Issues with the PAM12 proposal and derivatives

IEEE 802.3an Task Force

September 2004

Susceptibility Penalty over 1G

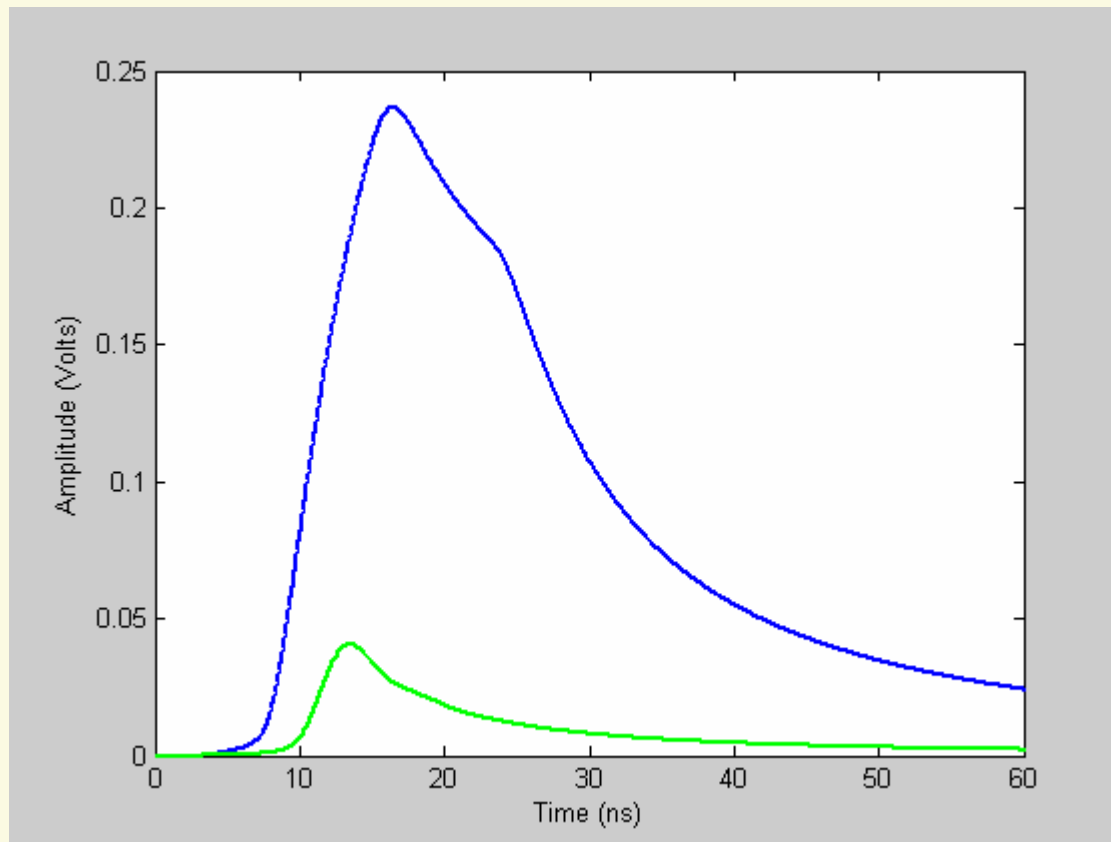
Susceptibility penalty is **15.3dB** over 1G after 100m cabling

2. Analog Front End Distortion Requirement

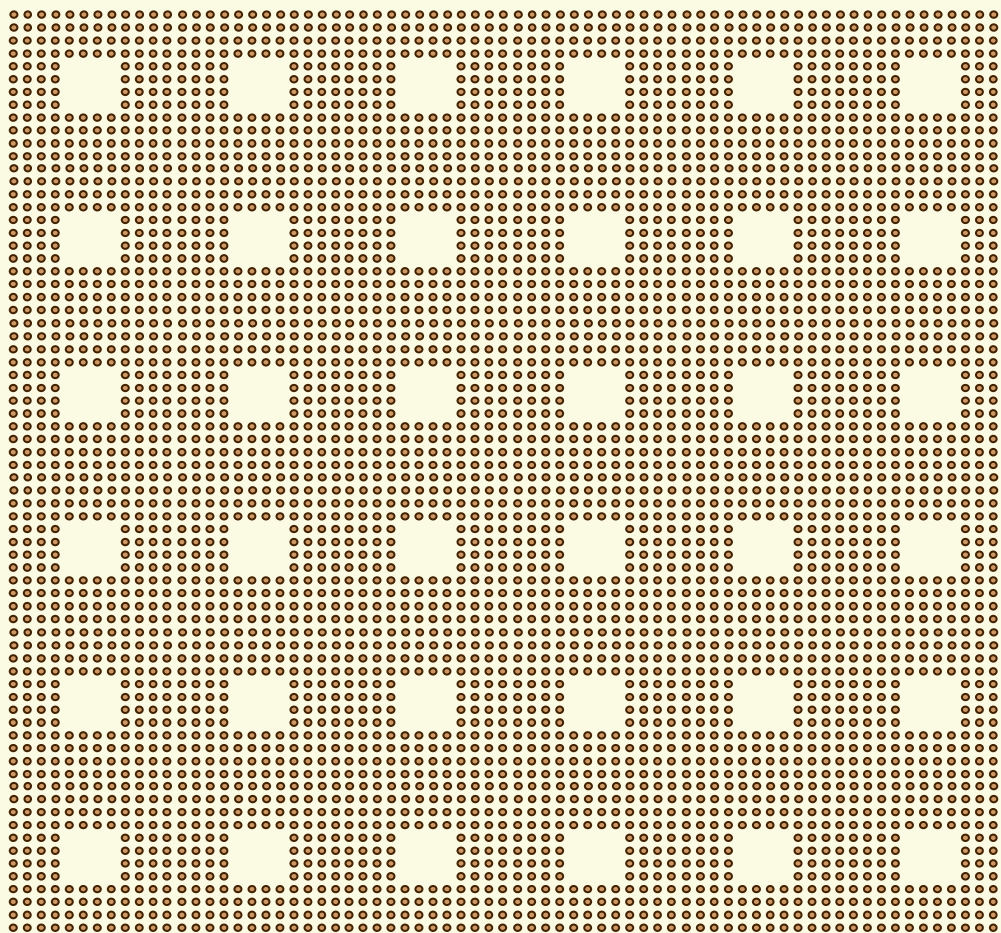
- ❏ SNR Required at the input of the LDPC decoder for PAM12 is **23.8dB** for 1E-12 BER
- ❏ SNR Required at the input of the LDPC decoder for PAM8 is **19.9dB** for 1E-12 BER
- ❏ If implementation budget is proportionally allocated, then the Analog Front End distortion requirements would be **3.9dB** higher for PAM12 than for PAM8.
- ❏ Analog Front End Distortion Requirement for Double Square Constellation and derivatives are : ??

Proposed Cross Constellation

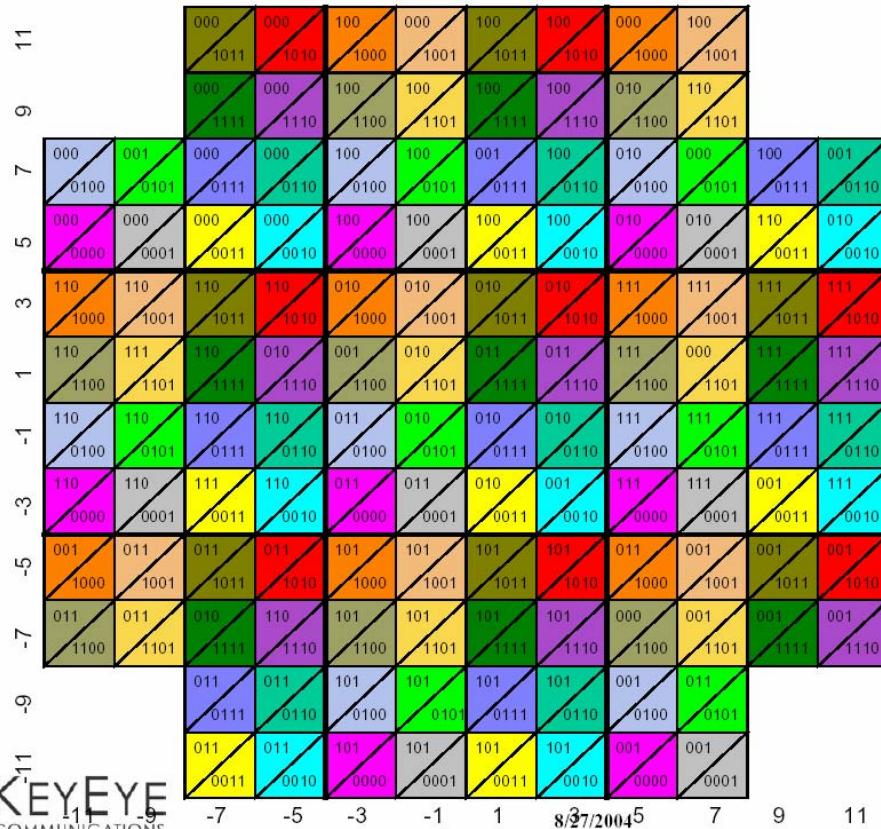
- ☞ At least 1.1dB loss in SNR margin due to holes in the constellation
- ☞ 0.4dB to 0.7dB variation in transmit PSD power as a function of the THP coefficients, depending on the constellation chosen.
- ☞ 2-Dimensional Log Likelihood Ratio calculations for 4 coded bits at a time in LDPC decoder which involves 2-pair statistics and adds dependencies in the Tanner graph that can affect performance of the decoder.
- ☞ 2(Multi)-dimensional Log Likelihood Ratio calculations for Double Square constellation and derivatives are : ??

From tellado_1_0704.pdf, page 24

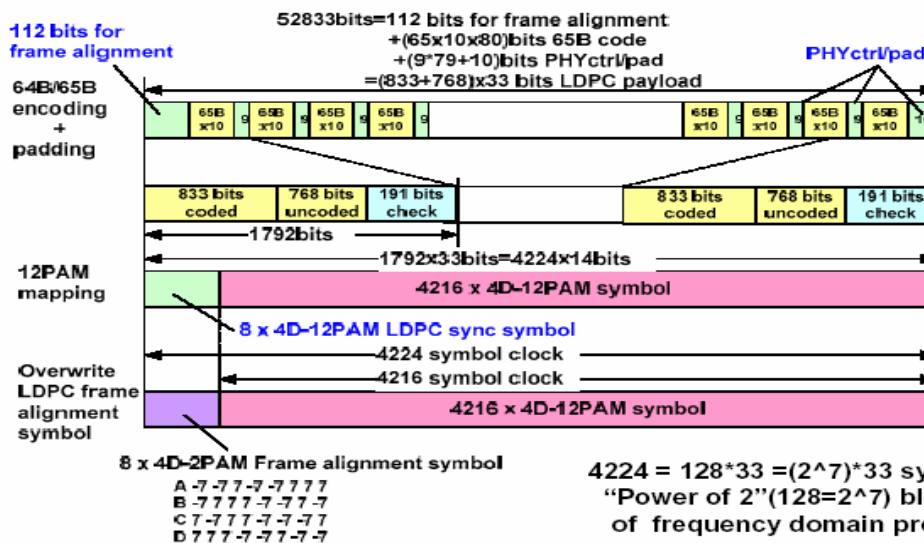
Framing Requirement for Double Square Constellation and Derivatives are ??

From tellado_1_0704.pdf, page 24

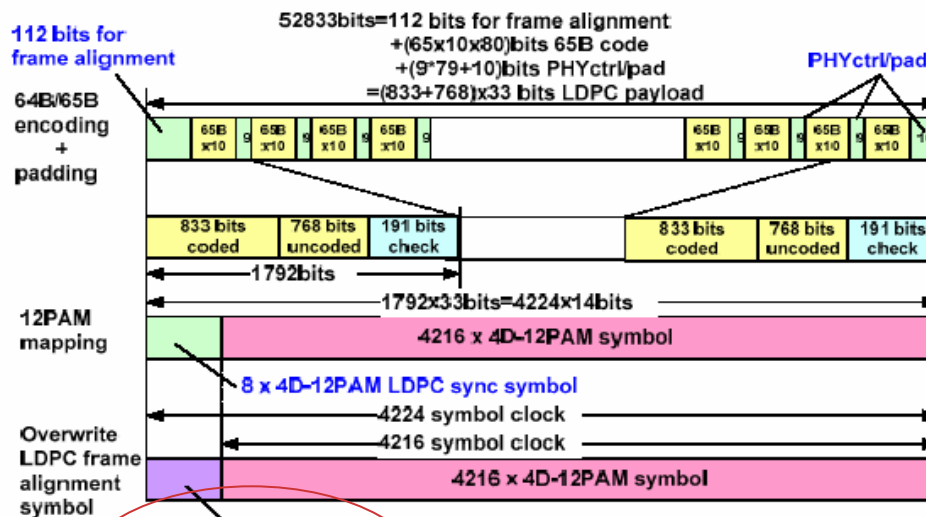
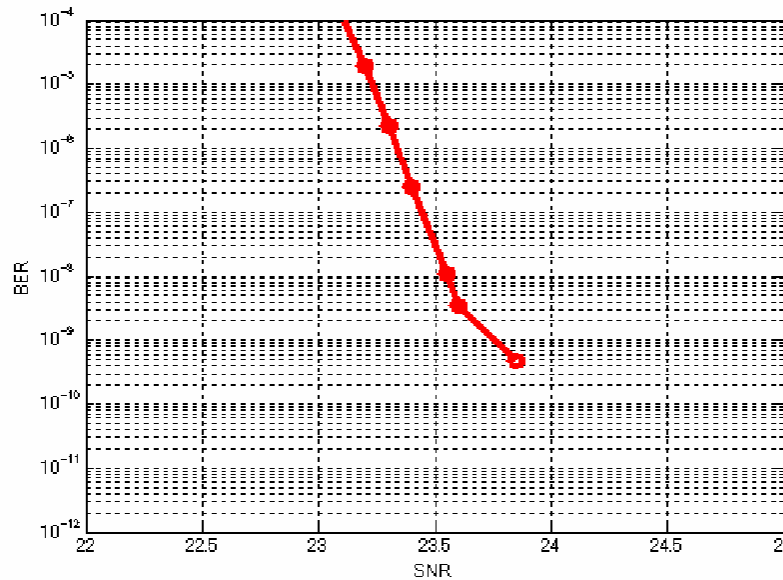
- ☞ Like preamble/SFD in Ethernet packets
- ☞ However, Ethernet packets are of variable length and have variable IPG – therefore, preamble/SFD serve a purpose.
- ☞ Frames in the PAM12 proposal are of fixed length and have ZERO IPG – therefore, fixed patterns occur at predictable points in data stream and serve NO purpose.
- ☞ Fixed Patterns are ?? In Double Square Constellation and Derivatives.

LDPC(845,1024) Performance

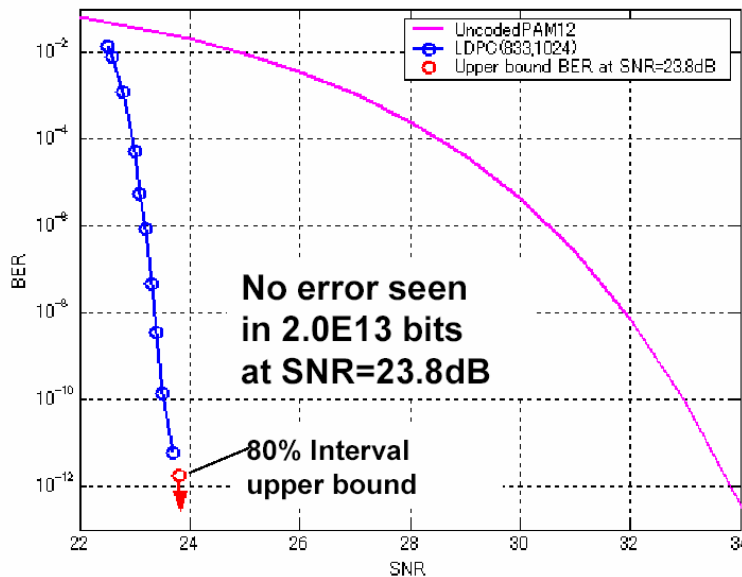
Has a BER slope change at unacceptable BER

6. Risky LDPC Code (Contd.)

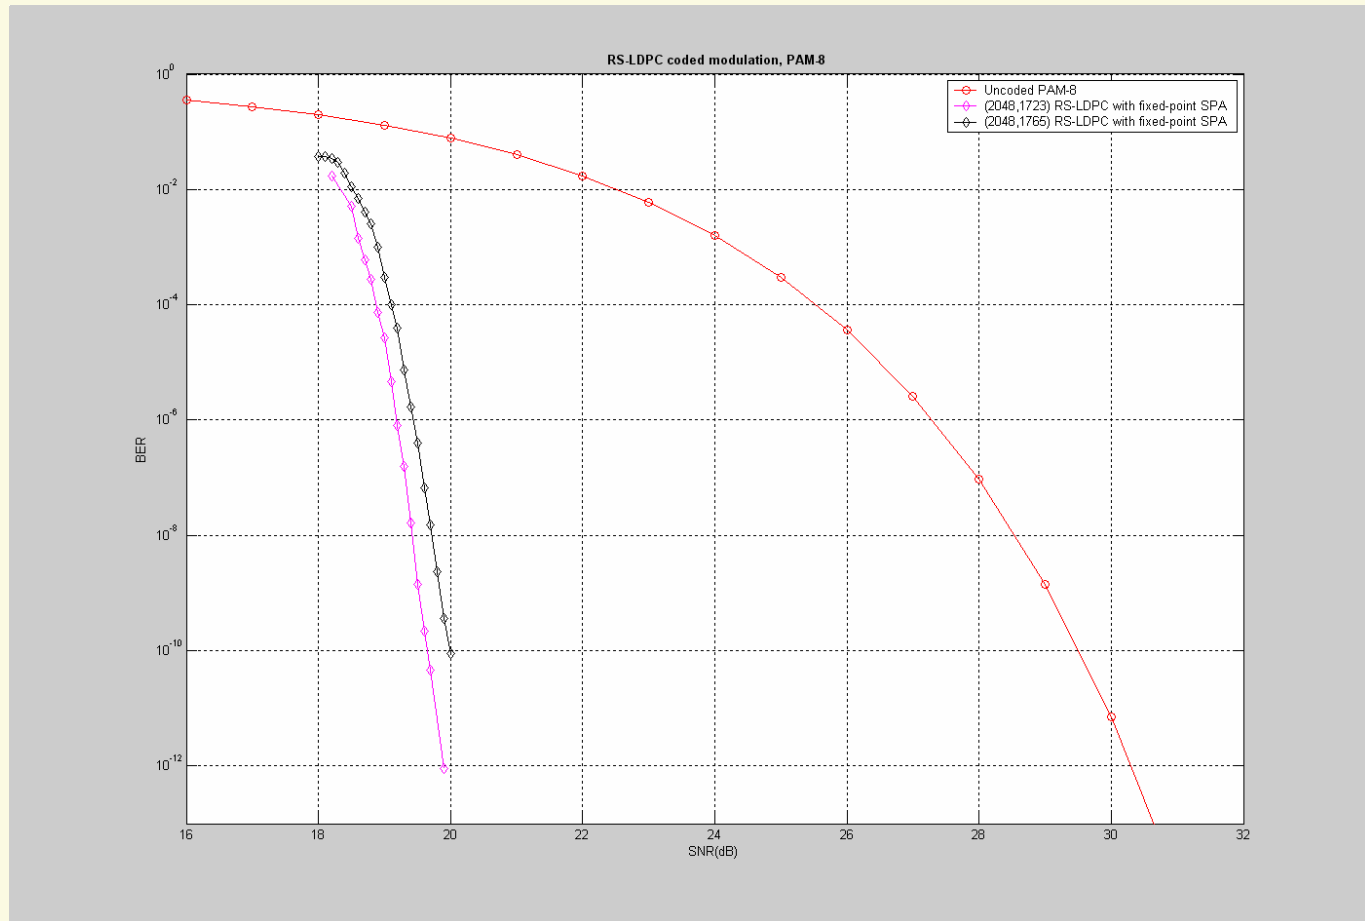
- ☞ However, (1024,833) code is obtained from (1024,845) code by adding 64 rows to its parity check matrix.
 - Of the 64 rows added, 52 rows are dependent rows since the number of information bits only decreased by 12.
 - 12 rows are new checks, augmenting the original 179 parity checks

- ☞ 179 parity checks cause BER slope change at $\sim 1E-10$ BER and result in bad code that was thrown away in `seki_1_0704.pdf`
 - How robust would the code be if we add 12 parity check equations to these 179 parity check equations?

- ☞ LDPC code(s) used in Double Square Constellation and Derivatives are ??
